August 22, 2025

USD 321 Rossville High School Addition and CTE Renovation – JGR Proj #22-3269

ADDENDUM NO. 2

CIVIL PLANS
UTILITY PLAN

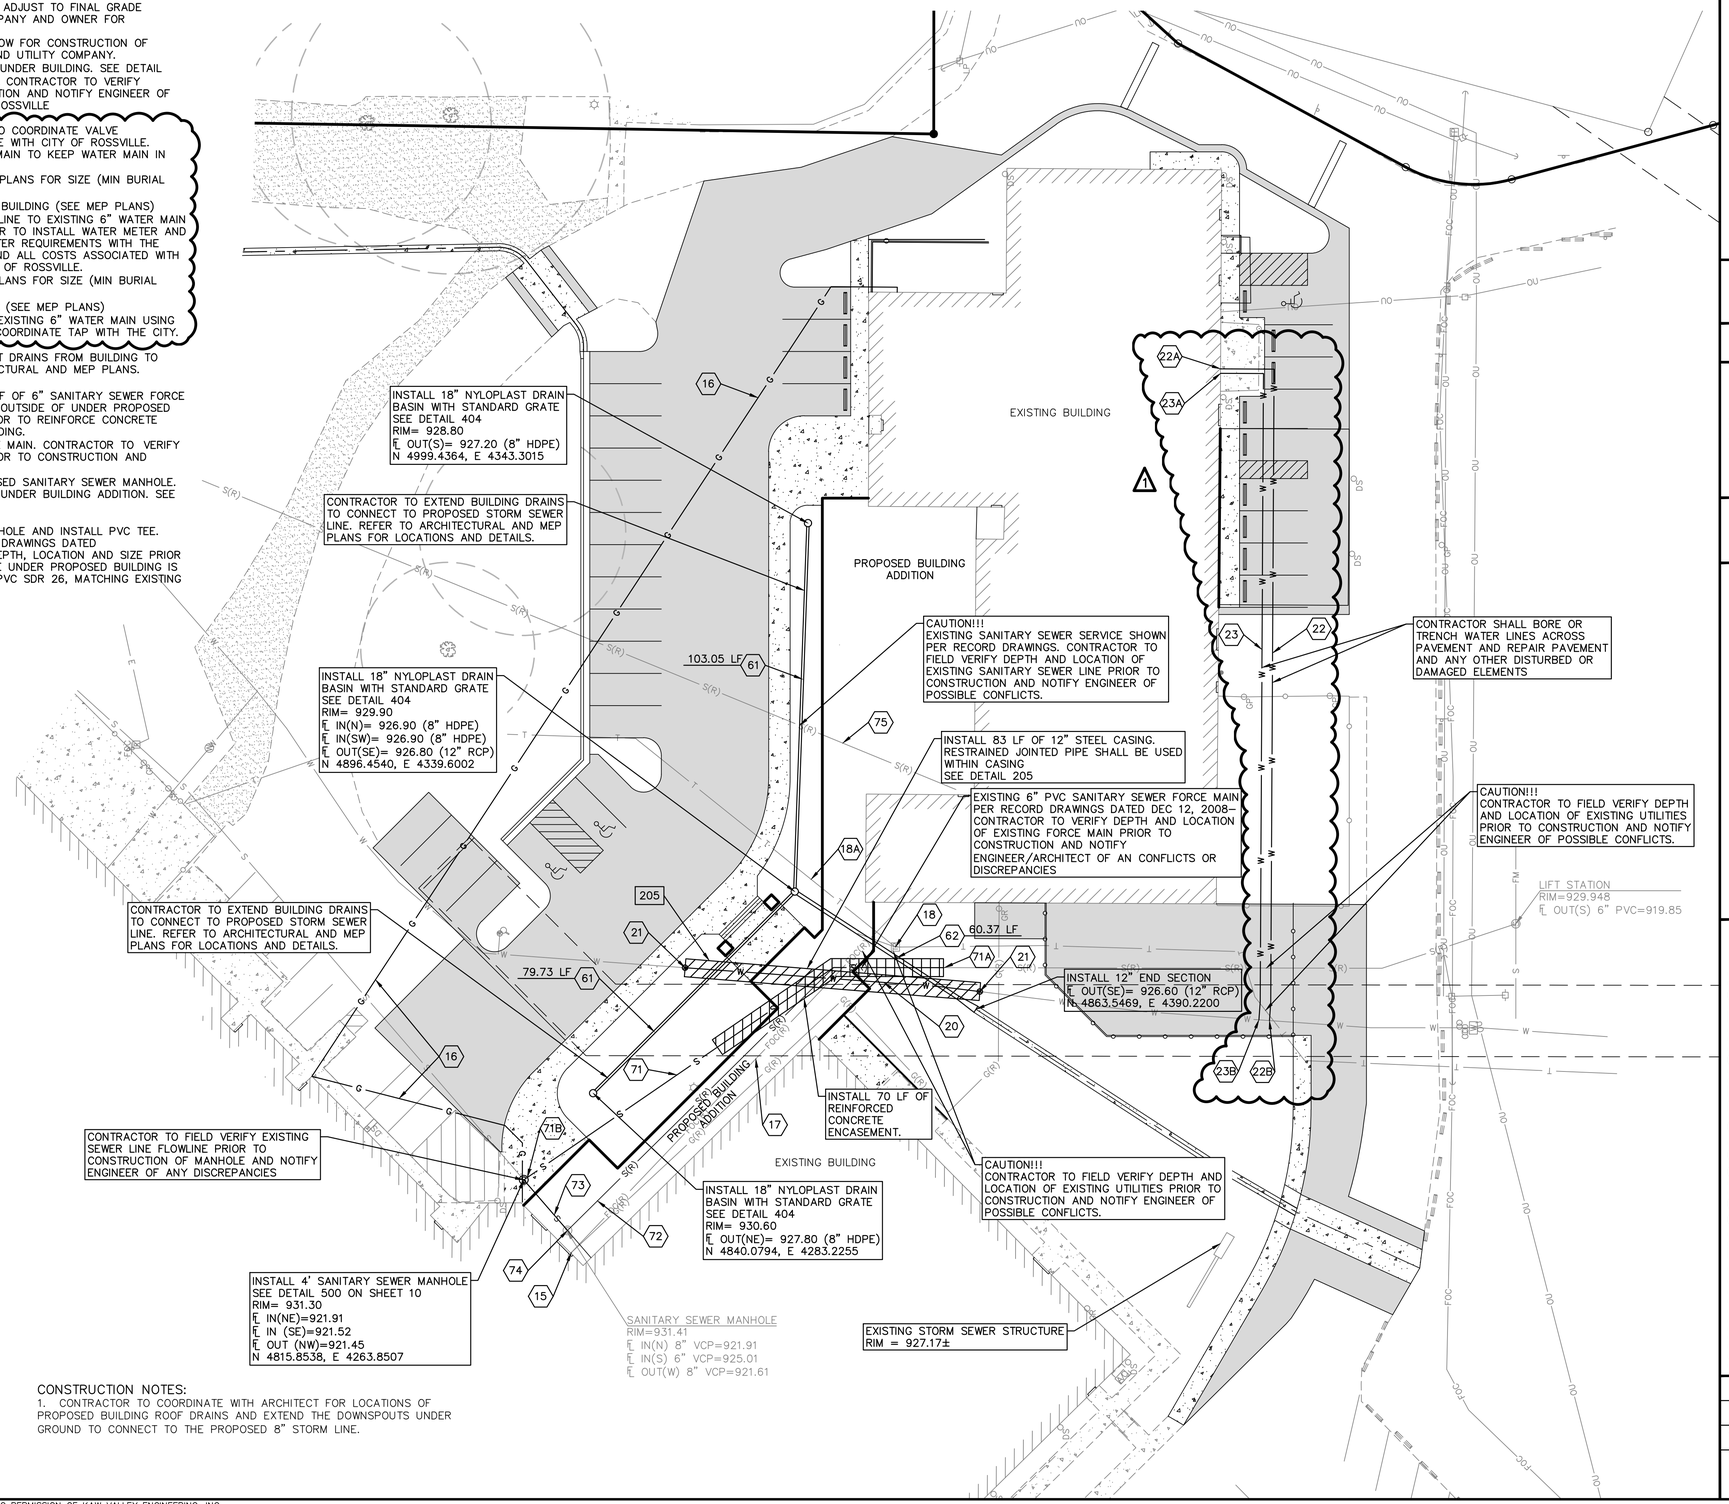
1. Sheet 08 Utility Plan – Reference the attached revised sheet 08 providing clarification for routing and tapping of the new domestic water and 6" fire line.

21 INSTALL 6" WATER GATE VALVE. CONTRACTOR TO COORDINATE VALVE INSTALLATION AND REPLACEMENT OF WATER LINE WITH CITY OF ROSSVILLE. CONTRACTOR SHALL HOT TAP EXISTING WATER MAIN TO KEEP WATER MAIN IN OPERATION.
22 DOMESTIC WATER SERVICE LINE. REFER TO MEP PLANS FOR SIZE (MIN BURIAL DEPTH 42")
22A DOMESTIC WATER SERVICE LINE CONNECTION TO BUILDING (SEE MEP PLANS)
22B CONNECT PROPOSED DOMESTIC WATER SERVICE LINE TO EXISTING 6" WATER MAIN USING TAPPING SLEEVE AND VALVE. CONTRACTOR TO INSTALL WATER METER AND PIT. CONTRACTOR TO COORDINATE TAP AND METER REQUIREMENTS WITH THE CITY. CONTRACTOR IS RESPONSIBLE FOR ANY AND ALL COSTS ASSOCIATED WITH WATER METER AND TAP. COORDINATE WITH CITY OF ROSSVILLE.
23 FIRE PROTECTION WATER LINE. REFER TO MEP PLANS FOR SIZE (MIN BURIAL DEPTH 42")
23A FIRE PROTECTION LINE CONNECTION TO BUILDING (SEE MEP PLANS)
23B CONNECT PROPOSED FIRE PROTECTION LINE TO EXISTING 6" WATER MAIN USING TAPPING SLEEVE AND VALVE. CONTRACTOR TO COORDINATE TAP WITH THE CITY.

1 ME ROOF PLAN - AREA 1
1/8" = 1'-0"

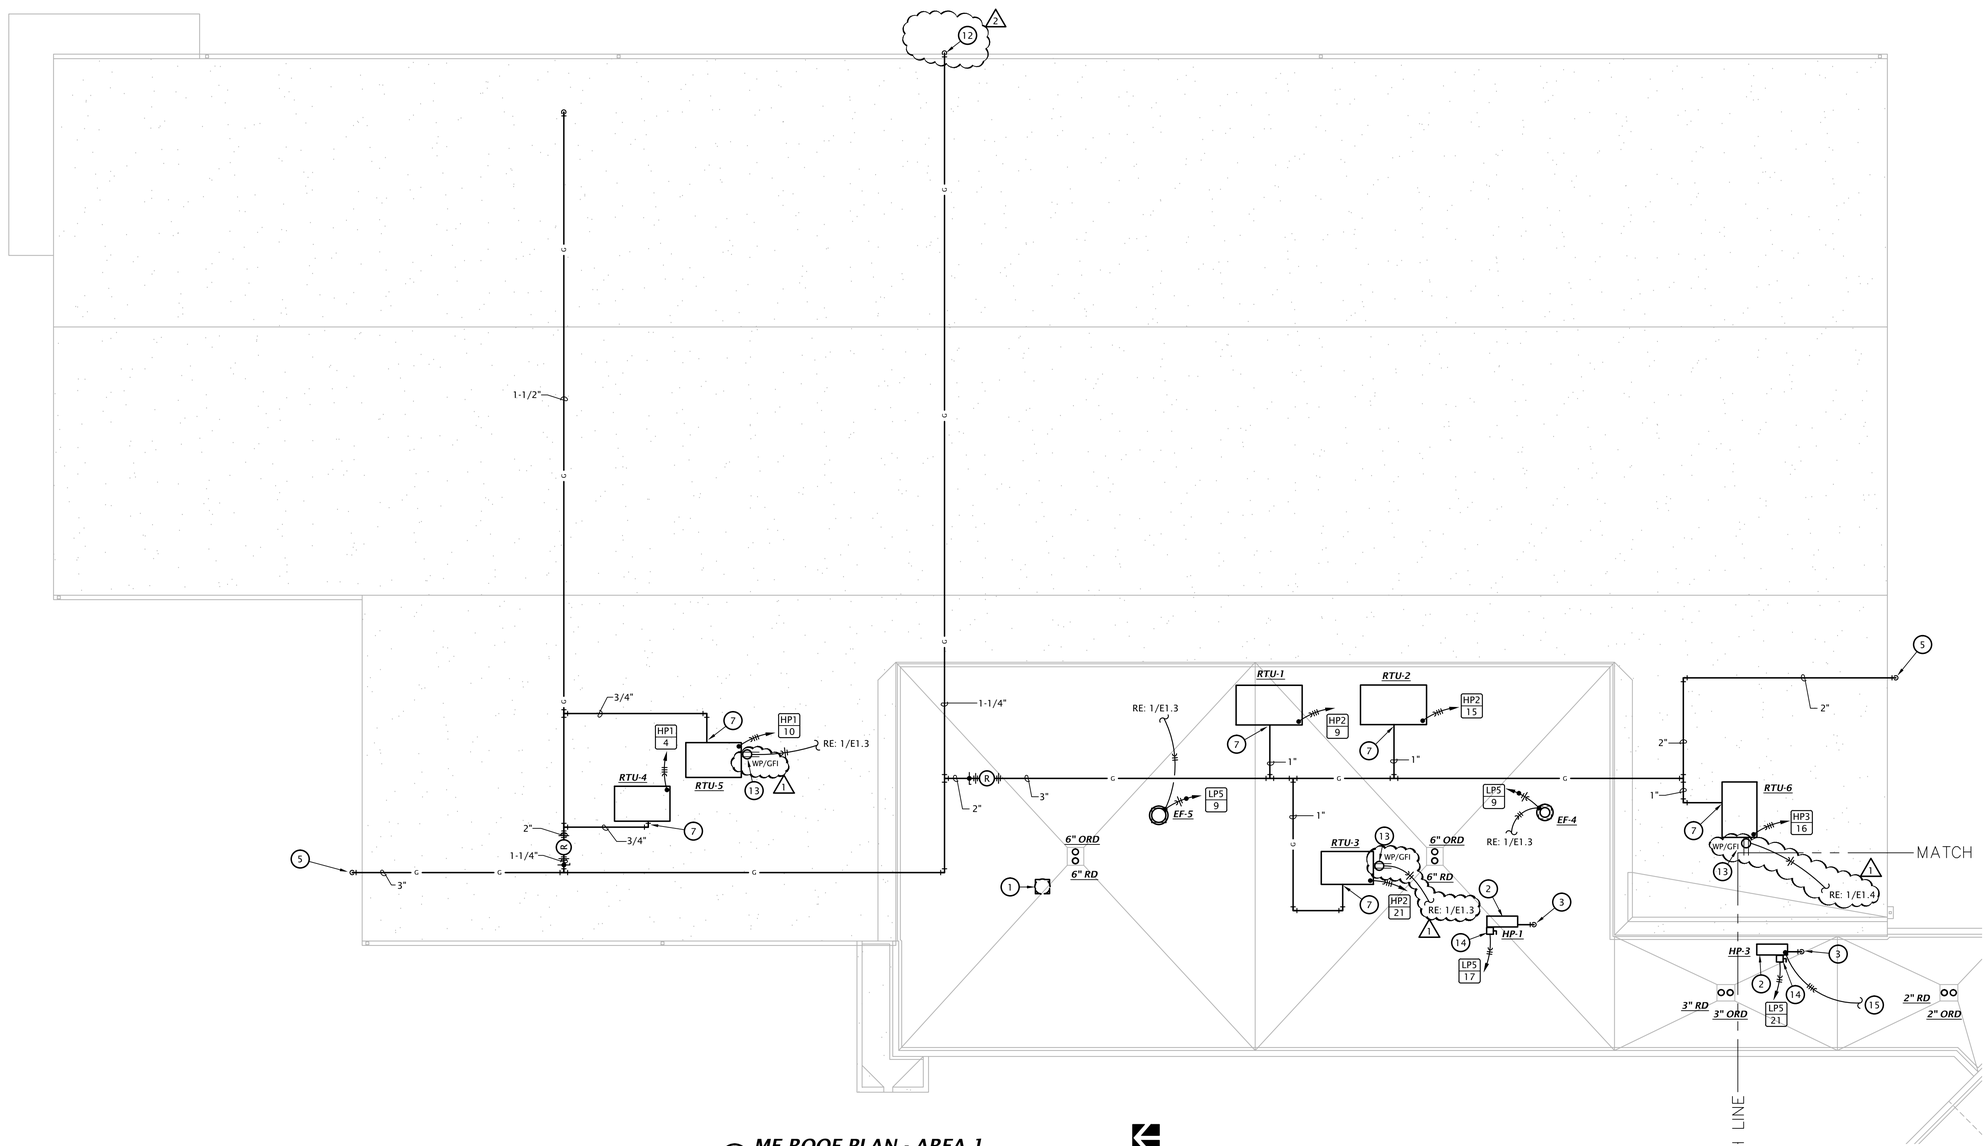
1. Sheet ME1.6 ME Roof Plan - Note 12 was missing. Note 12 was added pointing to the gas line to the paint booth make-up air unit.
2. Sheet M1.1 Waste and Vent Plan - Water closet in RR 139 was changed to a flush valve water closet.
3. Sheet M1.1 Waste and Vent Plan - Water closet in RR 139 was changed to a flush valve water closet.
4. Domestic water line and fire protection line routing was modified and note was added to see continuation of pipe routing on Civil Drawings.
5. Remove Furnace Split System Schedule from sheet M6.1. Equipment will be installed previous to project start and will be existing.
6. Coordinate duct installation requirements for paint booth with paint booth supplier. Provide all required hangars and supports and roof and wall penetrations for paint booth mechanical equipment, coordinate exact requirements with paint booth supplier.

11. PROVIDE PIPE CURB AND ROUTE GAS PIPING DOWN THROUGH ROOF. COORDINATE EXACT REQUIREMENTS WITH G.C.
12. ROUTE 1 PSI GAS PIPING DOWN ALONG EXTERIOR WALL AND CONNECT TO SPRAY BOOTH MAKE-UP AIR UNIT INCLUDED AS PART OF ALTERNATE #4. PROVIDE GAS COCK, UNION, AND DIRT LEG. COORDINATE EXACT LOCATION AND CONNECTION REQUIREMENTS WITH EQUIPMENT PROVIDED BY OTHERS. WORK ASSOCIATED WITH ALTERNATE #4 SHALL BE PRICED SEPARATELY.
